City of Alexandria, Virginia

MEMORANDUM

SUBJECT: 4th CONCEPT REVIEW OF 500 & 501 NORTH UNION STREET
(FORMERLY ROBINSON TERMINAL NORTH)
BAR CASE # 2014-0119

BOARD OF ARCHITECTURAL REVIEW SUBMISSION
DECEMBER 16, 2014

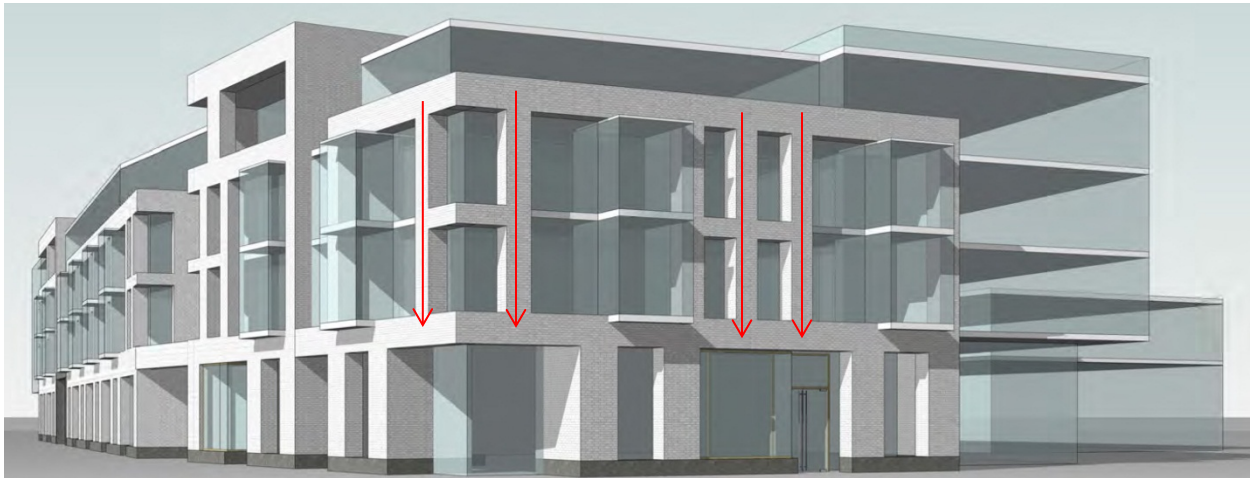
Another fundamental change to the previous design is the vertical articulation of the building bays at key locations and elimination of the uniform cornice overhang that had been unfavorably compared by some to the Kennedy Center. Although portions of the masonry frame now extend above the third floor in two locations, the third floor cornice still clearly defines a setback at the basic 30 foot height required in §6-404 of the Zoning Ordinance. This visual break in the roofline allows the building to better achieve another requirement of §6-404, which requires that the “bulk and mass” be compatible with the historic streetscape of Alexandria. The applicant’s perspective looking north on N. Union Street (Figure 2) shows a roofline that more accurately recalls a historic Alexandria block (Figure 3.)

Figure 1: In this interim design study, red arrows show the load path of the upper stories bearing on a masonry beam - something atypical of traditional building techniques in historic masonry architecture. At the same time, the heavy piers on the first floor precluded views into the retail spaces fronting N. Union Street (process study on current submission Sheet A4).

Figure 2: Red arrows in the present proposal show the load path traveling directly to the ground, a character-defining feature of Alexandria's historic masonry architecture, with large storefront windows below each bay

providing a visually interesting streetscape for pedestrians and establishing a building bay width that relates to the scale of nearby townhouses (current submission Sheet A6).

Figure 4: East elevation of East Building with Pavilion Option 8

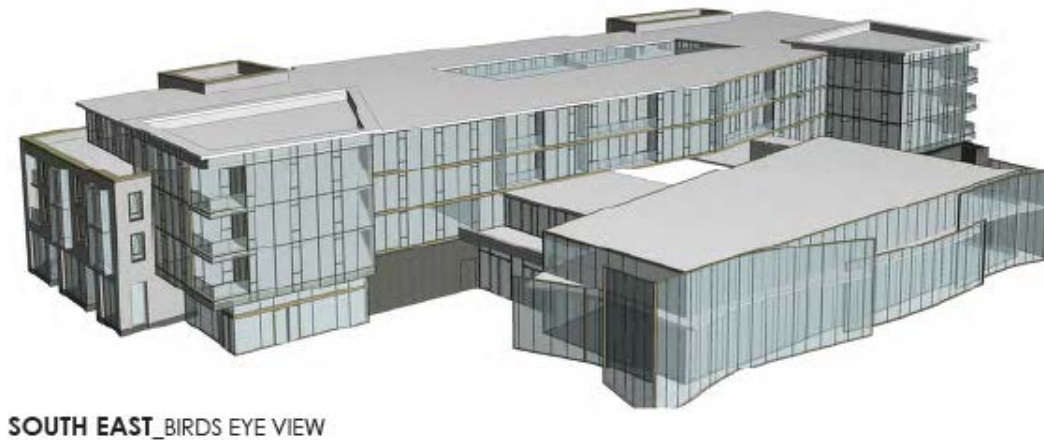
As with the east elevation of the west building, the east elevation of the east building is now a more rational and organized bookend plan with two projecting and slightly taller masses separated by a glass running wall. A unified and greatly simplified window muntin pattern ties the building together and forms a more neutral backdrop on the east side as a foil for the pavilion. The hyphen connecting the main building to the pavilion has been reduced in size to allow the pavilion to appear freestanding and to have its own distinct artistic character.

A1

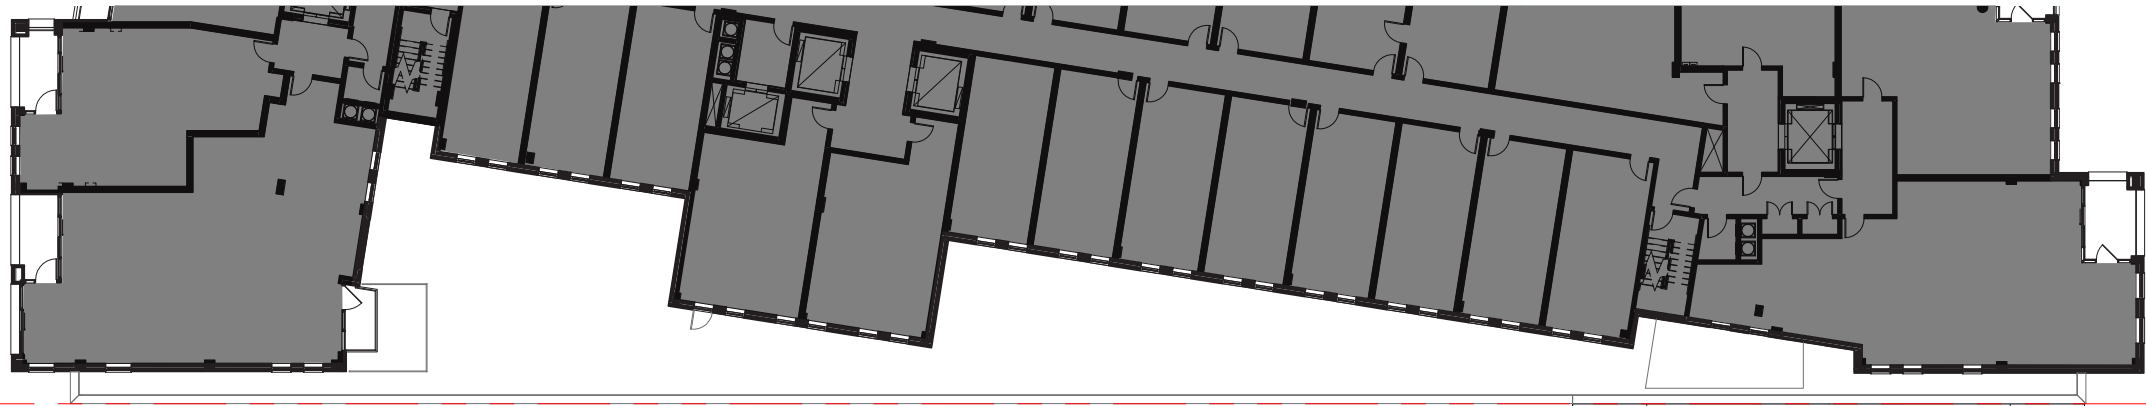
Based on the discussion at the last work session, the applicant has made a few refinements to the rear (west) elevation of the west building. These include variation in the brick color and depth to emphasize paired windows, belt courses that align with adjacent cornices, and additional windows. These organize and give scale to the large wall by providing a base, middle and top, and enliven the rear elevation of the building. The applicant has also provided much better renderings of the west elevation that explain the substantial modeling of the wall and the depth of the wall offsets (Sheet A2) which are sculpturally rich, viewed in perspective from the north and south. The west side will never be viewed the way it is represented in the direct elevation drawing, and the dashed lines on Sheet A1 show that the majority of this elevation will be screened from the west by existing adjacent structures.

The brick color in the rendering remains unaltered from what was previously shown to (and rejected by) the BAR at the last hearing. Staff has asked the applicant to provide material samples to the Board at the hearing so that the Board can better evaluate the color selections for both buildings.

A8

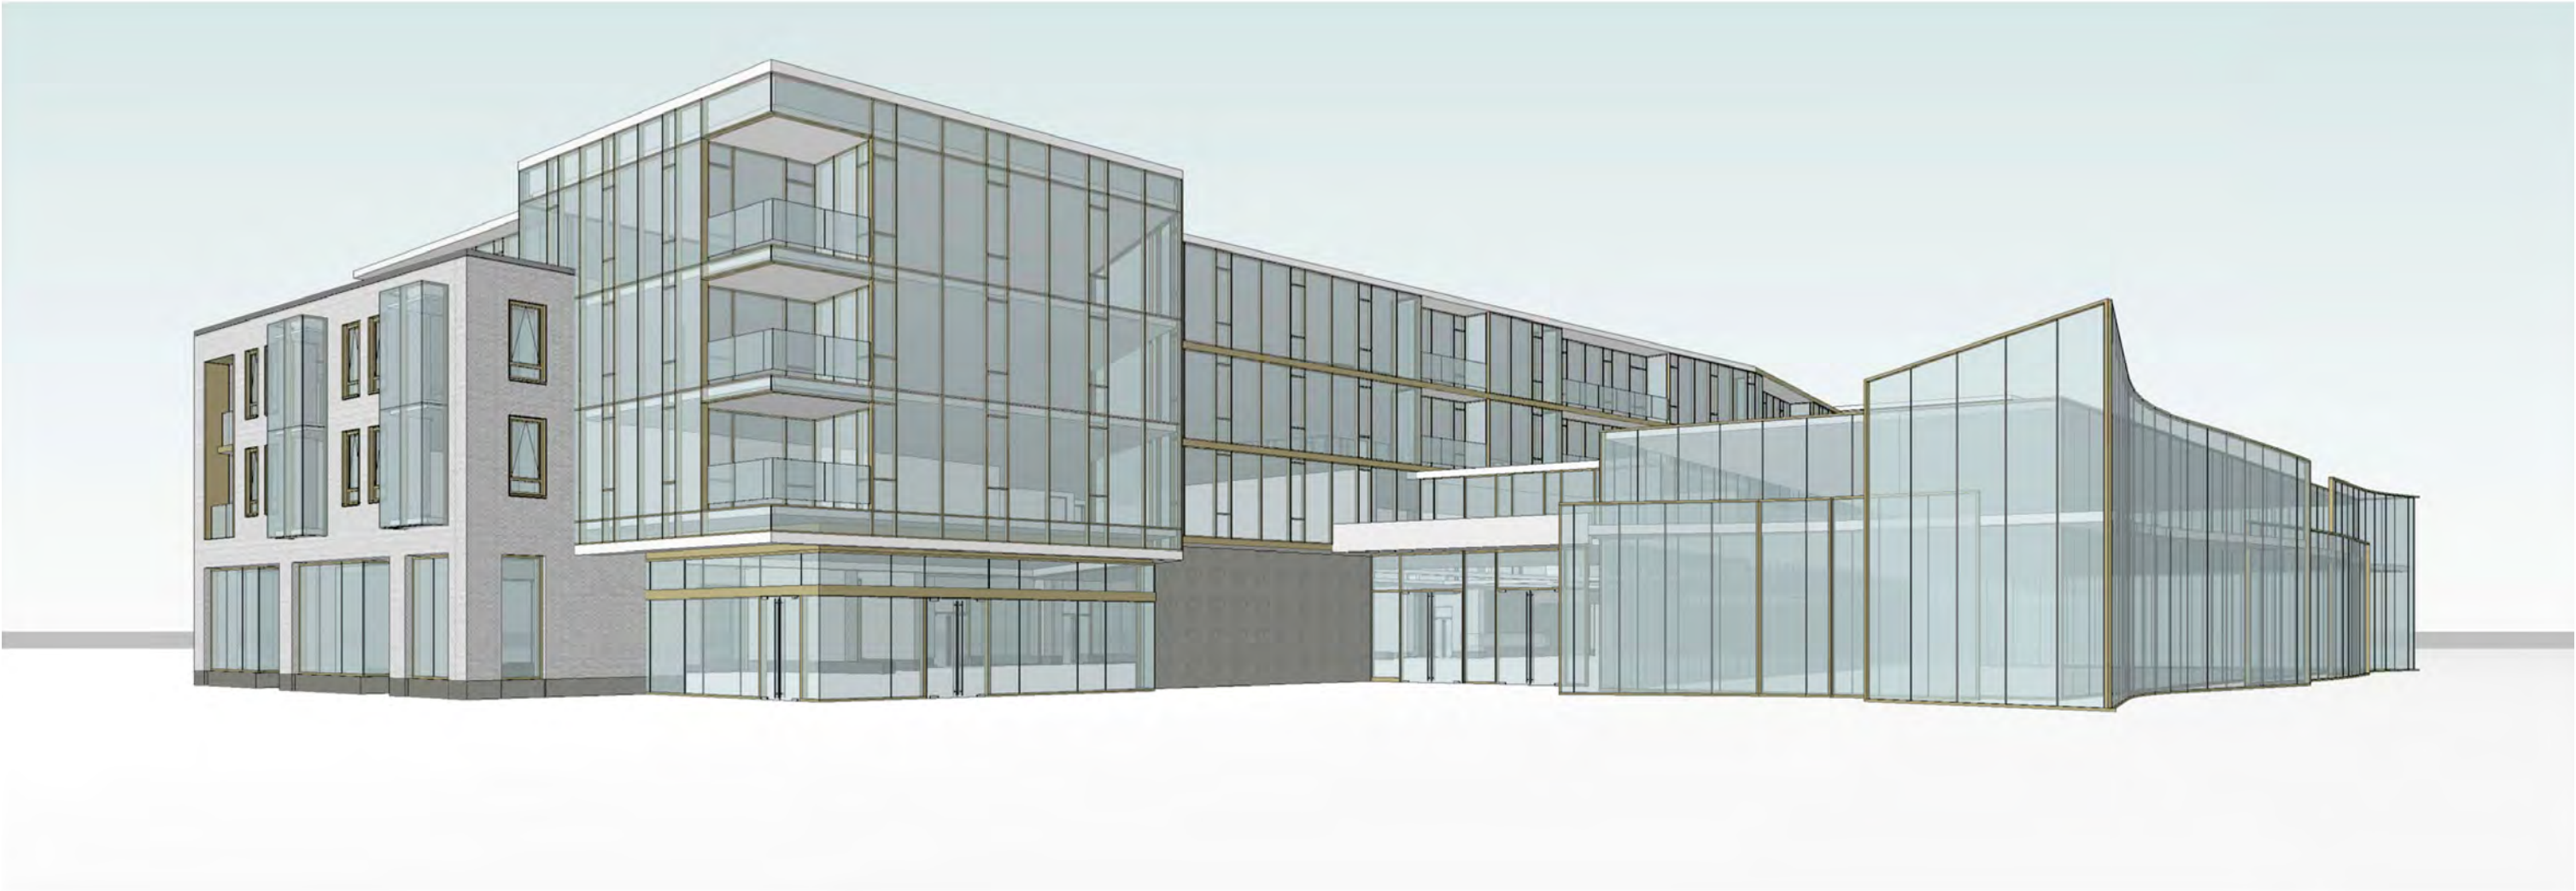
Like the east elevation, the north elevation facing the river is largely glass, as recommended by the BAR, and floats above the stone art wall/loading dock screen (Sheet A8). The applicant acknowledges that this elevation is the least developed at the present time and requires work around the loading dock entrance to maintain adequate utility screening, provide visual support for the upper floors and integrate the historic interpretation artwork on the stone wall.
